**New York Power
Authority**

July 16, 1991
JPN-91-037

SUBJECT: James A. FitzPatrick Nuclear Power Plant
Docket No. 50-333
Request for Additional Information -
Proposed Changes to the Technical Specifications
Spent Fuel Pool Storage Capacity (JPTS 90-035)

**RESPONSE TO NRC REQUEST 2 FOR ADDITIONAL INFORMATION
SPENT FUEL POOL STORAGE CAPACITY INCREASE**

FIGURE 1

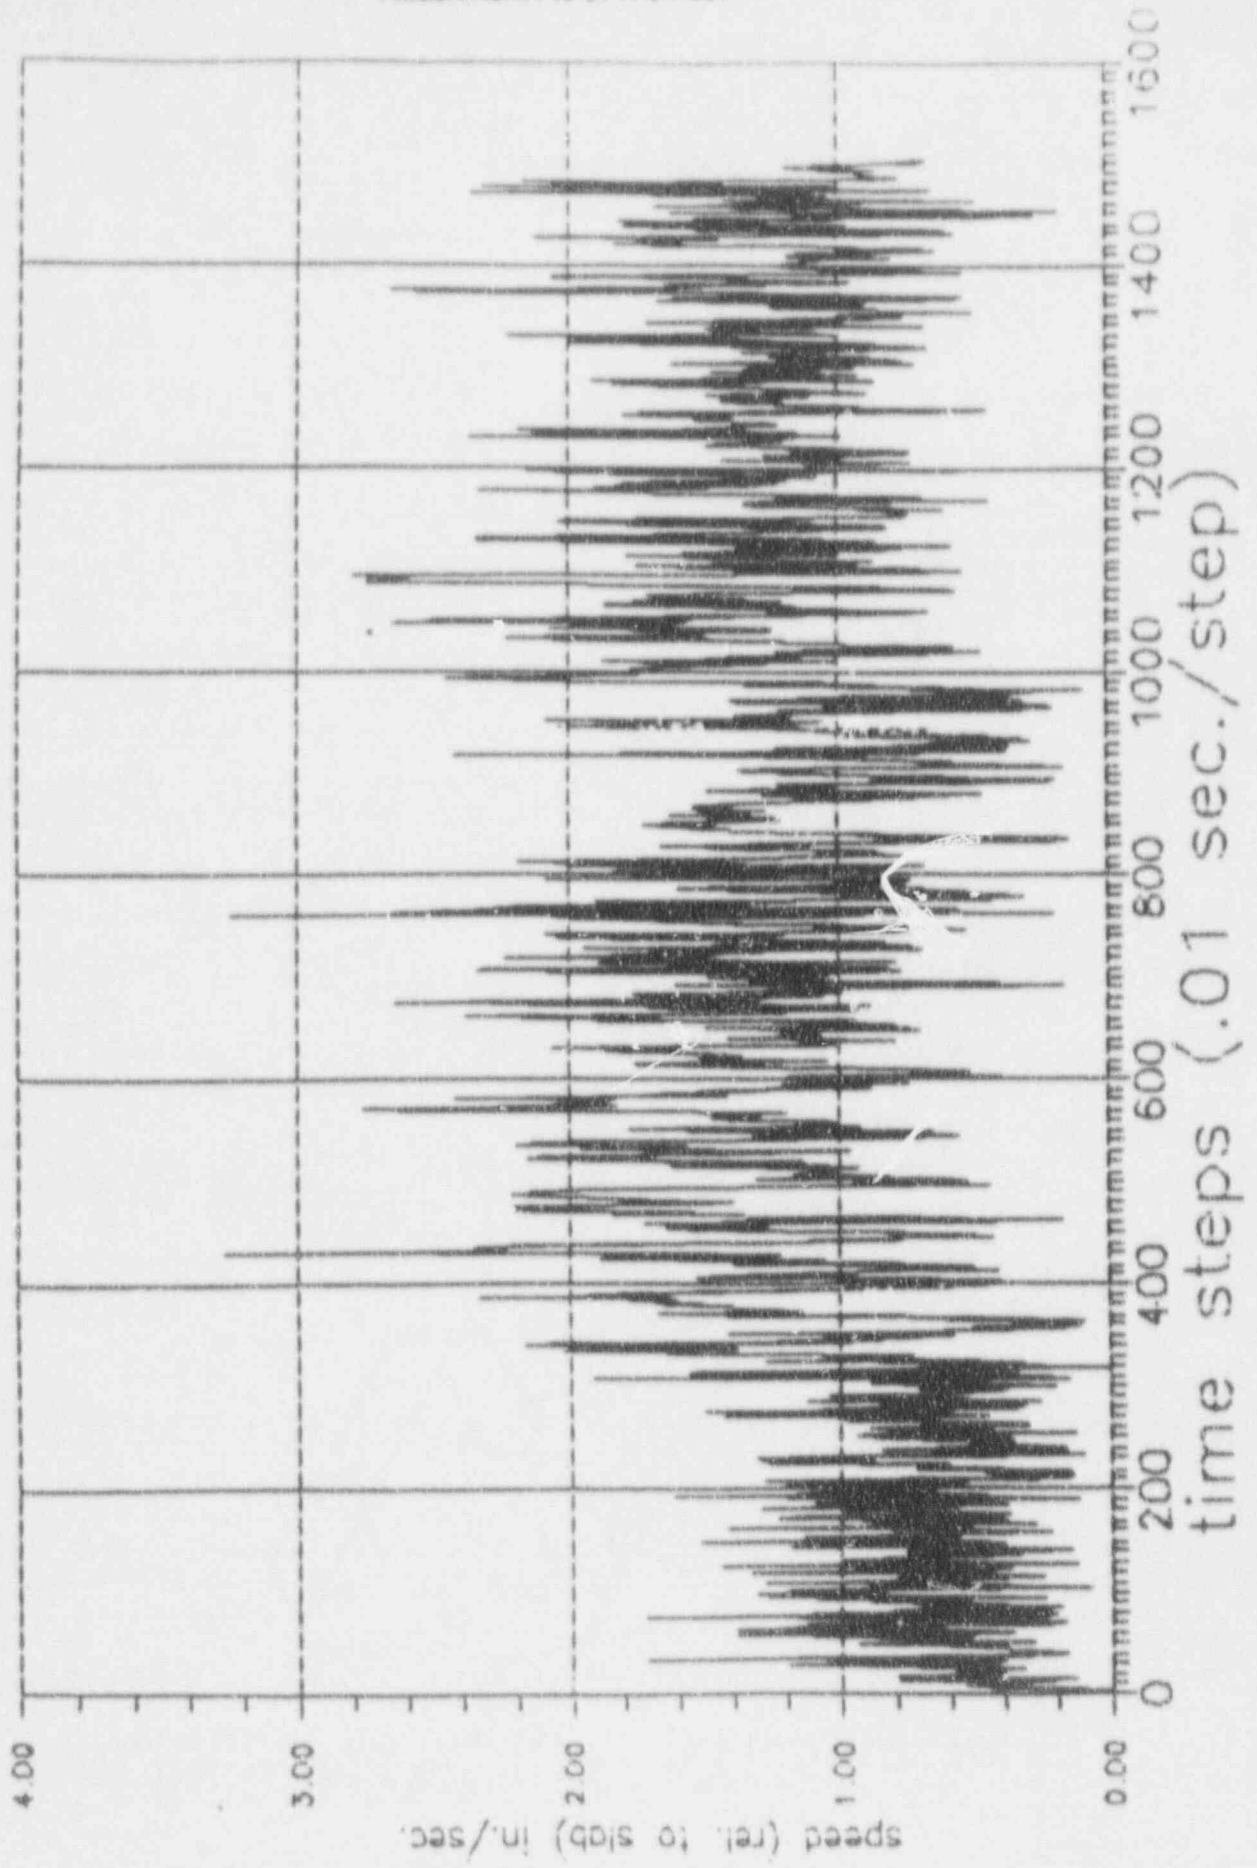
NRC Question 1 P. 6-4. It is stated that "lift off of the support legs and subsequent liner impacts must be modelled using appropriate impact (gap) elements, and Coulomb friction between the rack and the pool liner must be simulated by appropriate precise [sic] linear springs."

Discuss, with specific examples, how one simulates Coulomb friction by appropriate piecewise linear springs. Demonstrate that such model does simulate actual physical responses by means of experimental data or analytical solutions. Provide a discussion of mathematical basis of such model which was utilized in your computer program and provide a simple calculation whereby one can compare with a closed form solution or an alternate numerical approach to establish the validity of your solution.

Supplement to NRC Question 1 During a phone conversation, the NRC agreed that the Authority could show that the relative sliding velocity between the rack pedestal and pool liner is "low" enough so that a constant coefficient of friction may be used, instead of responding to the third part of NRC Question 1.

To determine the relative sliding velocity at the pedestal-liner interface, the Authority reviewed the results of one of the DYNARACK simulations. Specifically, the Authority examined the results from an analysis of the B rack (11x12). The net horizontal velocity of the pedestal base, relative to the floor was calculated as a function of time.

Figure 1 provides a plot of the net velocity V defined as:

where VX, VY are the instantaneous velocity in the X and Y directions, respectively. Figure 1 shows that $V_{\max} \approx 3.3$ in./sec, which the Authority considers "low". For such a "low" velocity, the variation in coefficient of friction will not be significant.

Figure 2

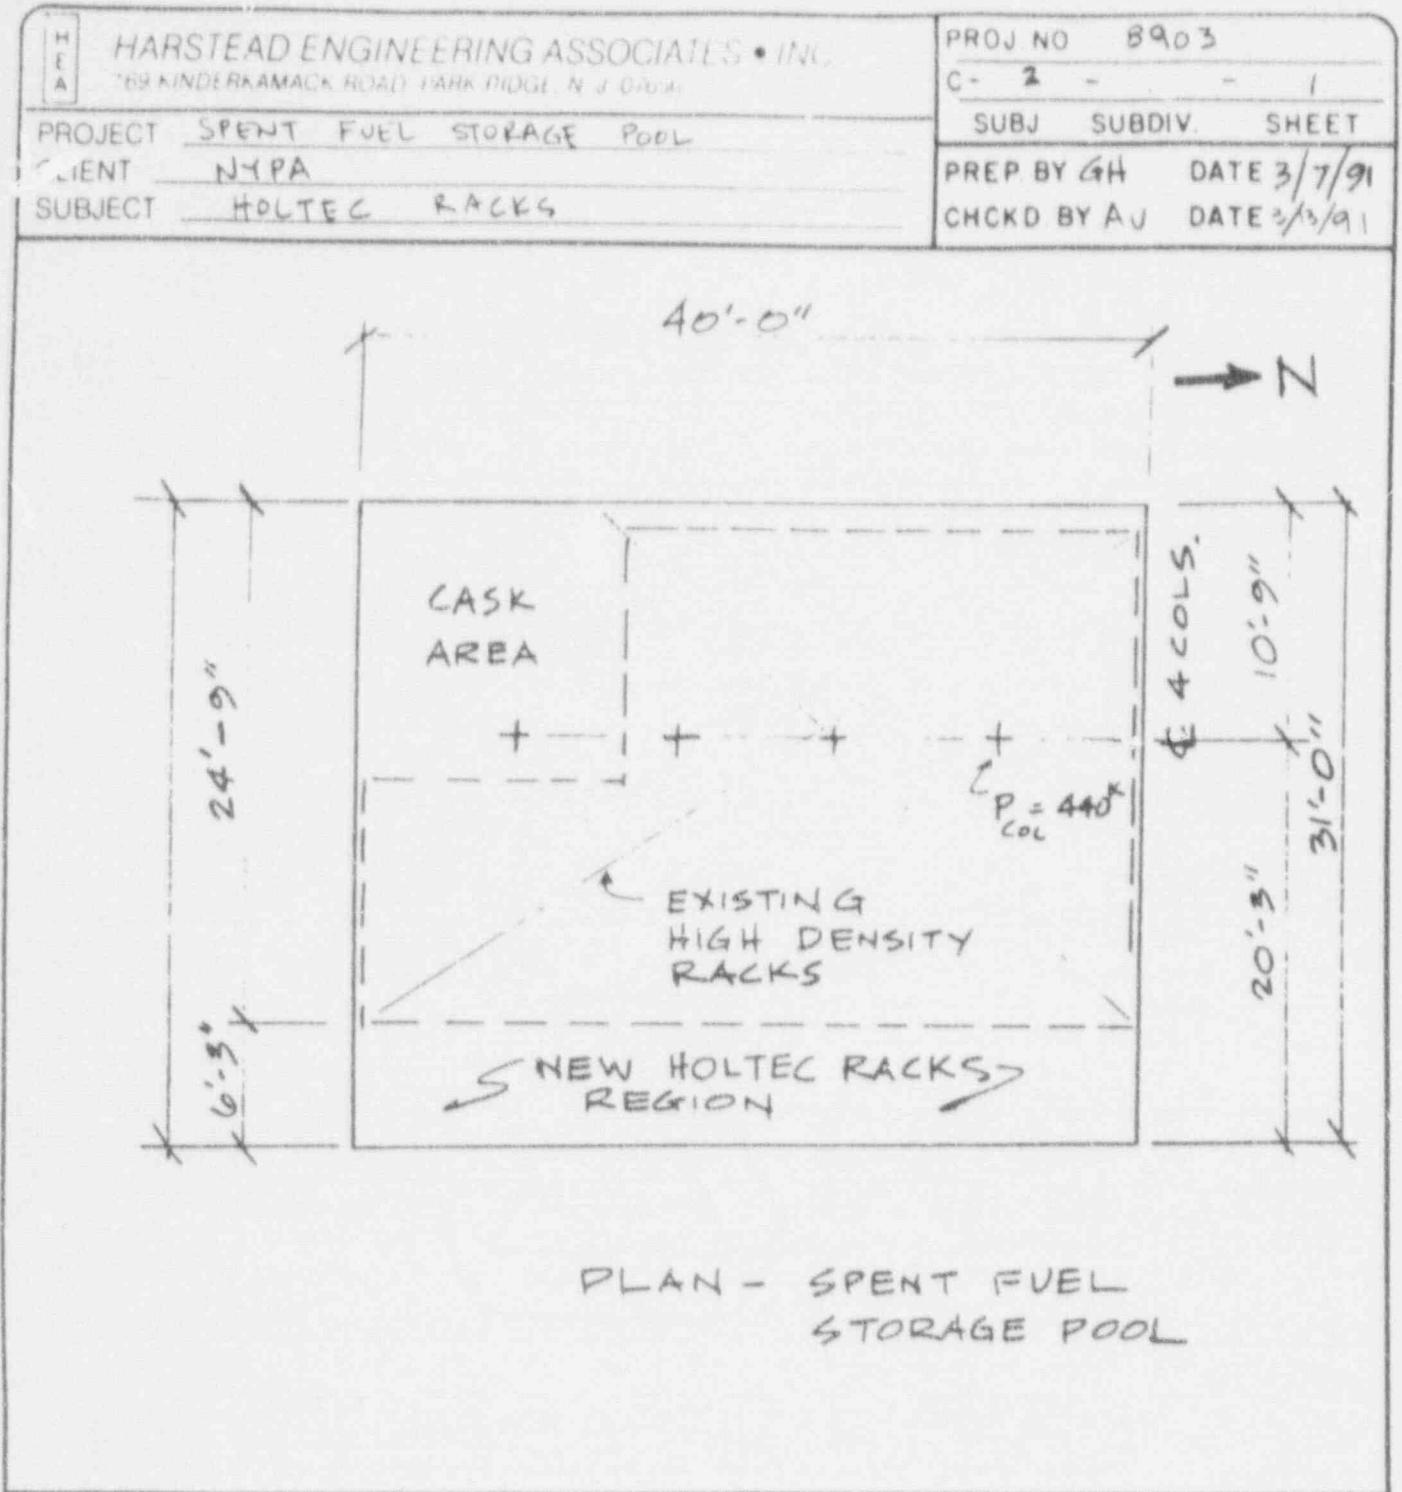
NRC Question 5 P. 9-1. Provide key stresses (or strength) and applicable margins that correspond to each load combination. Provide an estimate of the potential increase in stress (decrease in margin) if the current load is calculated using non-linear limit strength analysis. Also provide approximate increase in loads from current to proposed maximum loads for the pool structure.

Supplement to NRC Question 5 During a phone conversation, the NRC requested information about the spent fuel pool dimensions.

The critical location for the slab bending moment under the existing high density racks is at the west wall. However, the new racks are to be installed along the east (opposite) wall. Due to this location, the new racks will have no significant effect upon negative bending moments

along the west, north and south walls and only marginal effects, in fact, along the east wall itself.

The dimensions of the pool slab are 31' - 0" wide x 40' - 0" long x 5' - 0" thick. The slab is supported by four additional steel columns located 10' - 9" from the west wall. These columns are 24" in diameter with Belleville springs at the base. Each column was designed to provide a constant upward force of approximately 440 kips on the slab. These columns were added when the original racks were replaced with high density racks. Figure 2 provides a schematic of the spent fuel storage pool.
